# FINAL POST AUTHORIZATION CHANGE REPORT AND REVISED PROGRAMMATIC ENVIRONMENTAL IMPACT STATEMENT

## MORGANZA TO THE GULF OF MEXICO, LOUISIANA

MAY 2013

**REVISED PROGRAMMATIC  
ENVIRONMENTAL IMPACT STATEMENT**

**Figure 1-1. Project Area and Levee Alignment of the Tentatively Selected Plan**

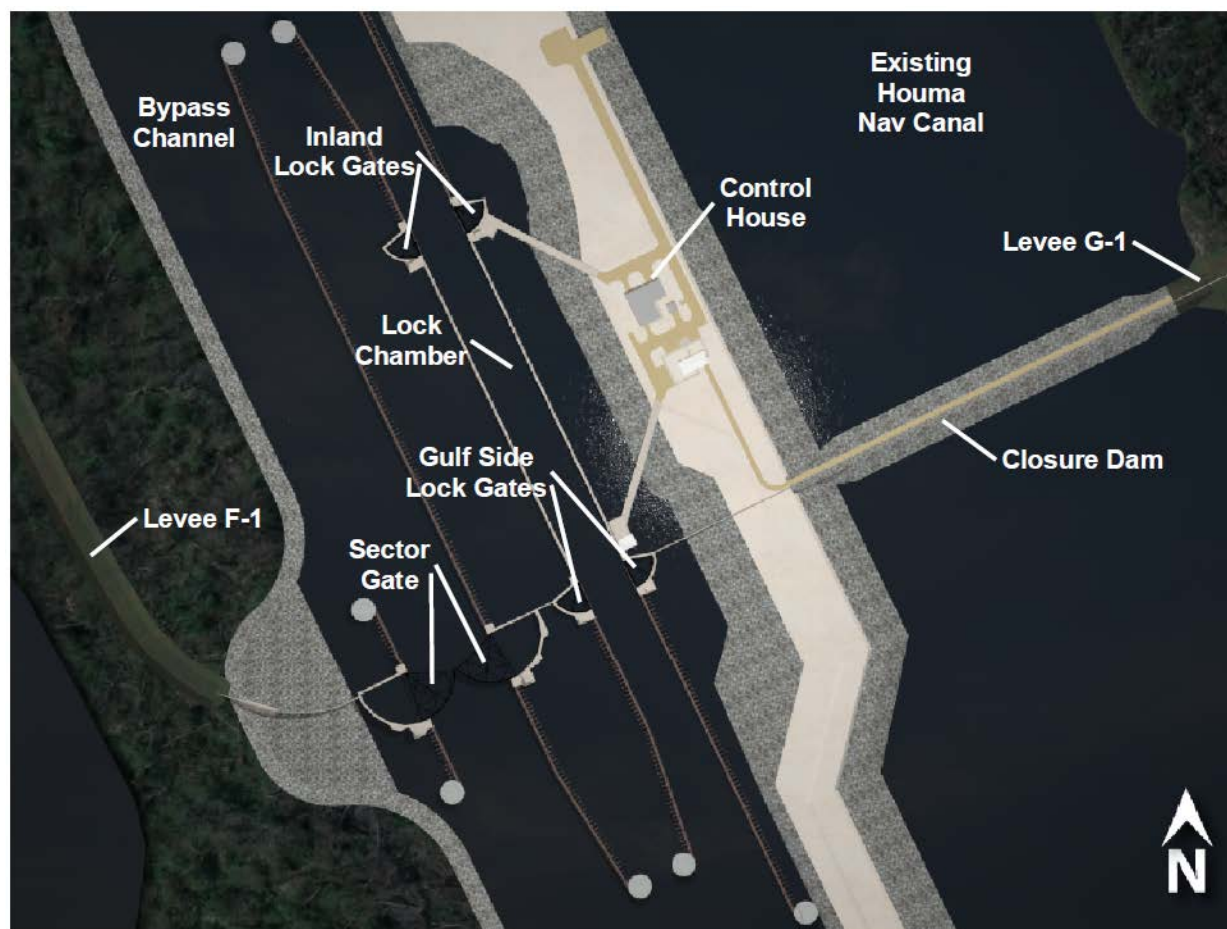
The project area has also changed since the preparation of this BA (RPEIS figure 1-1). Originally, offshore sediment was being considered as a borrow source. Offshore sediment is no longer being considered. Due to the elimination of offshore sediment, the project area has changed in the fact that it does not extend as far south. There is potential for some areas referenced in this BA to no longer be within the project area. Please reference the RPEIS for an updated project area and description.

**BA Pages 1, 7, 8:** Due to the elimination of offshore sediment use, whales are extremely unlikely to exist within the revised project area (RPEIS figure 1-1). Typically, no threatened or endangered species of whales occur in the nearshore waters of the Gulf of Mexico with the exception of the occasional sighting of right whales and humpback whales. However, these sightings are extremely rare.  
<http://www.offshoreoperators.com/marinedebris/Protected-Species-In-GOM-NOAA.pdf>

**Figure 4-1. Levee Alignment for Alternatives 1 and 4 (authorized alignment)**

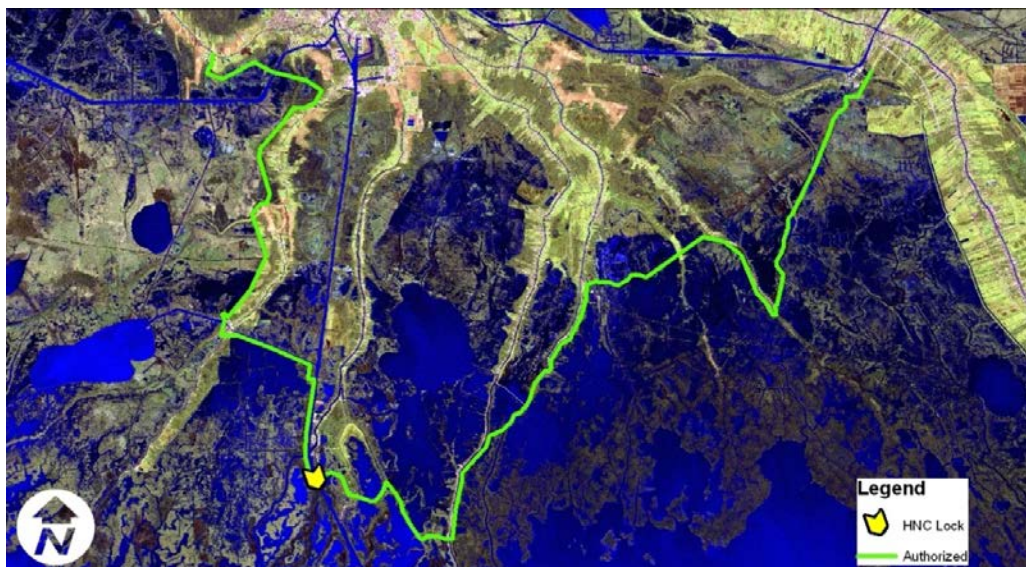
TLCD5	Editorial/clarification	Location of Structures Outside of Risk Reduction System (Figure 4-1--pg. 35)--The area of lower Chauvin/Cocodrie is mislabeled as Bayou Grand Caillou/Dulac. I suggest a brief summary of the 4 areas outside of the MTG alignment in Terrebonne would be beneficial. They are as follows (from east to west): 1. Isle de Jean Charles. 2. Lower Chauvin/Cocodrie 3. The Four Point area in lower Bayou Grand Caillou/Dulac. 4. Lower Bayou Dularge.	Map has been corrected and the descriptions provided above have been added to the PAC report.	PAC Figure 4-1
TLCD6	Editorial/clarification	Preliminary Evaluation of Alternative Levee Alignments (Sec 4.3--pgs. 36-40)--In 2008, the N.O. Dist. Corps evaluated 4 alternative alignments before moving forward with the PAC Report. One of these alternatives was (#3) suggested by NGO's and it is referred to as the "Multiple Lines of Defense Strategy". After this analysis, it was determined that the authorized alignment would be the most cost effective and least damaging to the wetlands. I suggest that the Final PAC report should refer back to the Memo from Gen Walsh to Col Lee in Nov, 2008 directing the Alignment to follow the authorized alignment. A copy of this Memo should be made part of the Report Appendices.	USACE guidance memos are not incorporated as appendices to feasibility reports because they are deliberative, internal agency discussions.	NA

**Figure 6-3. Average annual salinity differences (ppt) between No Action and Future with Project Condition (structures open)**

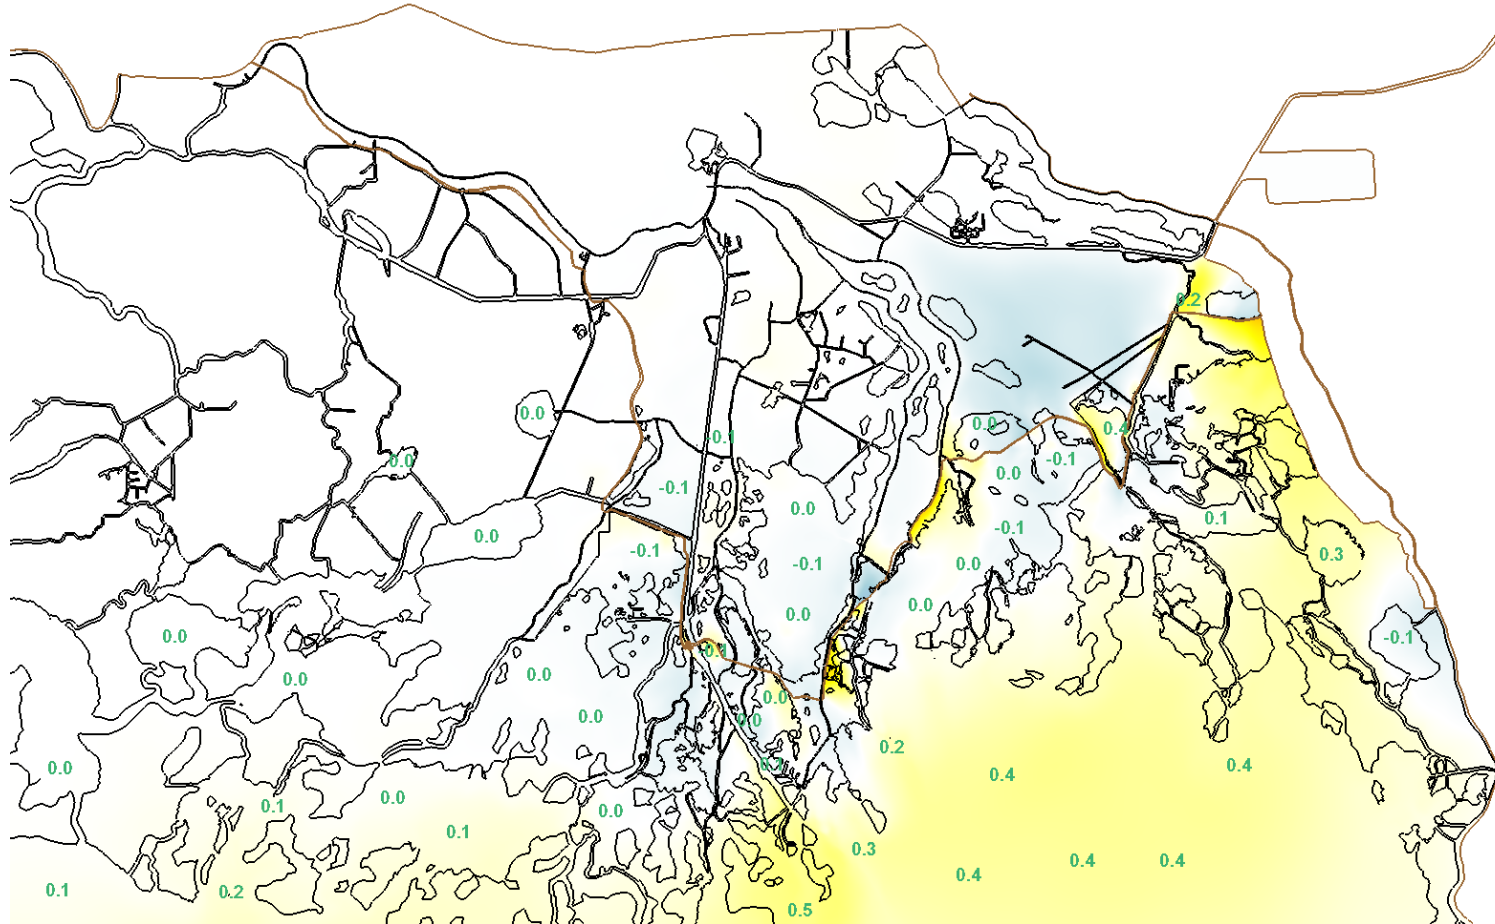
Draft RPEIS, Section 6.5.2, page 6-12, Second paragraph. The text references salinity increases illustrated by Figure 6-3. The text should also mention that modeling of this area (the Grand Bayou Unit on the Point au Chene Wildlife Management Area) did not factor in local water management capabilities that would remain unchanged under the with-project condition. Therefore, it is likely that the predicted salinity increase would not occur as management of the Grand Bayou Unit will continue.

Figure 6. Land Loss Rates for each Study Area Subunit

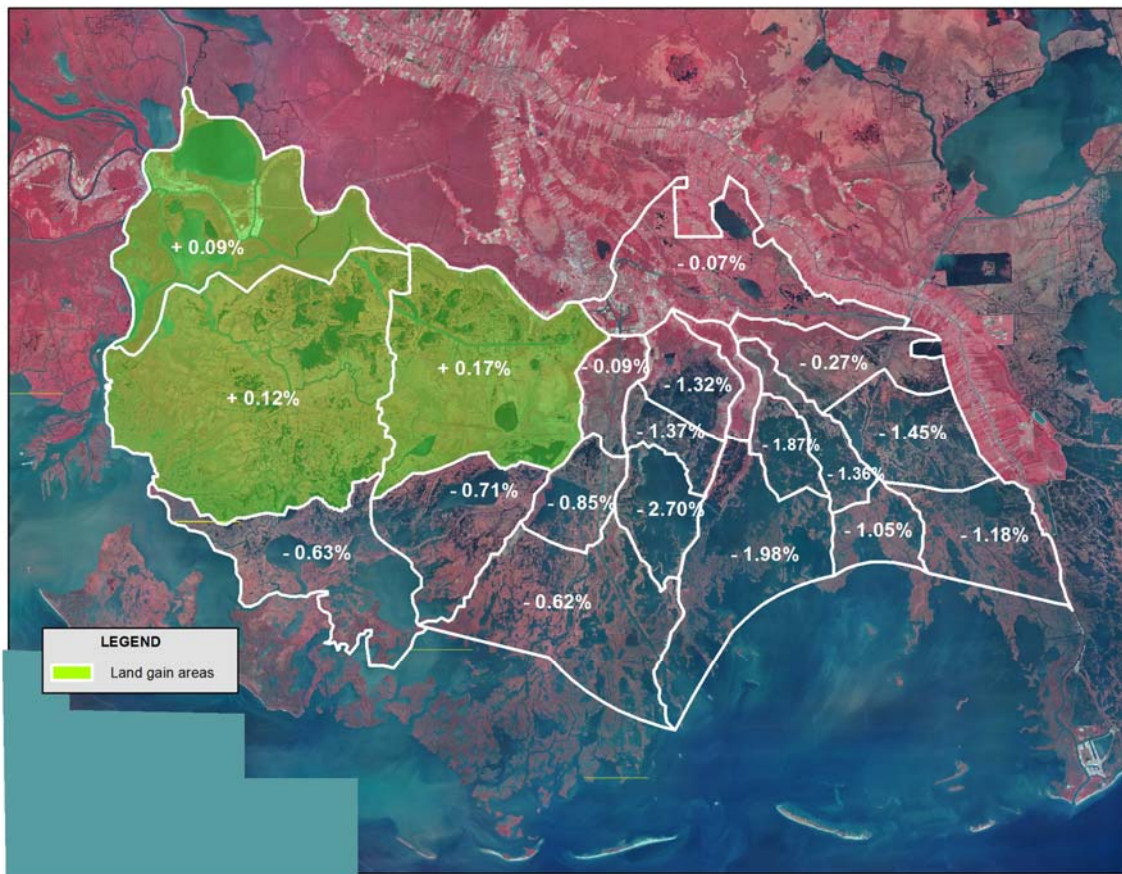
Page 15. The first paragraph references mitigation south of Falgout Canal and in Felix Lake as being located in subunits identified as B13 and B15, respectively. Figure 6 on Page 8 has the subunits labeled differently. However, NMFS concurs that B13 and B15 correspond with the described locations based on a different map provided during the planning process. It is suggested either Figure 8 be replaced with the alternative map or a second map be appended to the report to provide clarification.
